Section 42A Officer's Summary Statement

Proposed Plan Change 1 — Regional Coastal Plan — Kermadec and Subantarctic Islands

9 June 2026

Figure 1 — Map showing 300 m (plus extension) area for deletion.

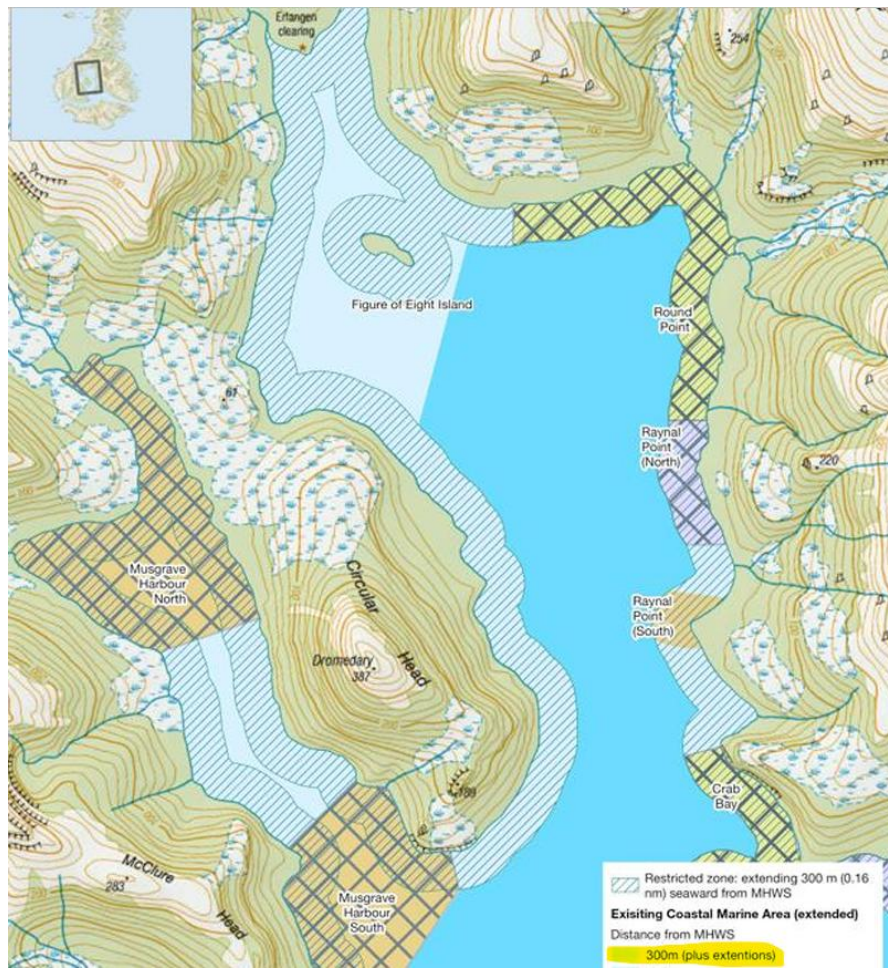
- f. Finally, Sam Penwarden has commented on Map 3¹⁰, in Appendix 1 of the proposed Plan which shows Carnley Harbour, Auckland Island. He notes much of the area known as the North Arm, in the northern reach of Carnley Harbour, is shaded light blue implying it is within 300 m of MHWS. This area has also been shown in the legend in Figure 5 of my s42A Report as “300 m (plus extensions).” Some of this area is not within 300m of MHWS. I understand this has been depicted on the map in this way, in the Plan, in recognition of the sealion breeding site at Figure of Eight Island. However, the relevant plan rules only refer to the zone 300 m from MHWS – not the extended light blue zone, I therefore agree with Mr Penwarden’s suggestion that Map 3 be amended to correct this (i.e., that the light blue area outside of 300 m from MHWS be deleted).
